COMMISSION OF ARCHITECTURAL REVIEW STAFF REPORT February 24, 2015 Meeting

10. CAR No. 15-012 (Instant Construction)

402-404 N. 29th Street

Extensive exterior alterations

Photo taken 10/31/2014

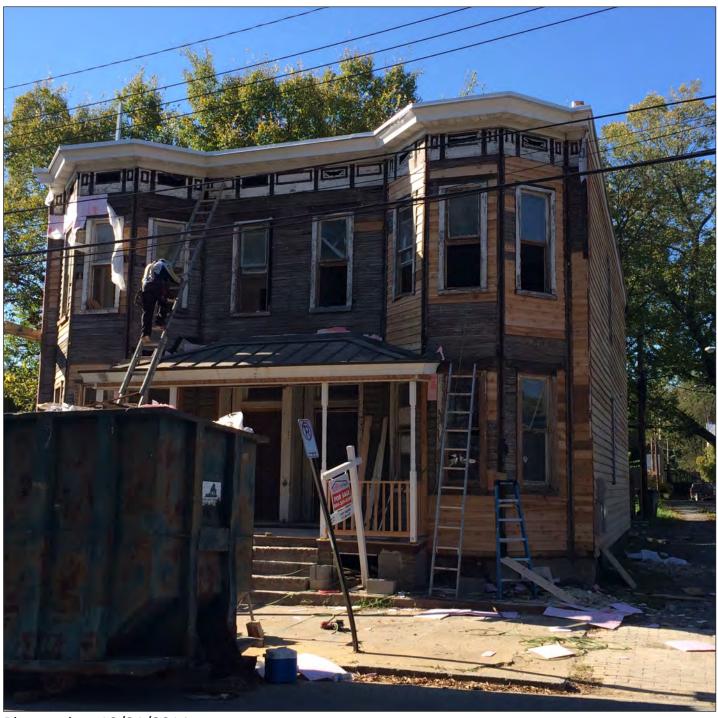
Before the work took place, the original frieze was covered by vinyl siding. The applicant states that the frieze was uncovered and subsequently restored with replacement wood where needed. However, photographs of the structure while work was on-going show the ghosting of the original frieze which does not match that of the installed cornice.

Various alterations were completed on the front porch. The flat seam metal porch roof was replaced with a black, standing seam metal roof. Simple, square porch dentils were installed at the cornice of the porch roof. The existing square porch columns were replaced with turned columns. The center porch column and railing were removed.

Staff recommends that the applicant return to the Commission with an updated application which details the restoration of the original roof frieze as evidenced by the ghosting of the original feature, as well as restores the features of the porch, including the center railing between the two sides, to their original condition. In regards to the siding, an amenable outcome could be the salvaging of all original beaded siding to the front façade of the structure, reserving the side and rear elevations for the new, replacement siding.
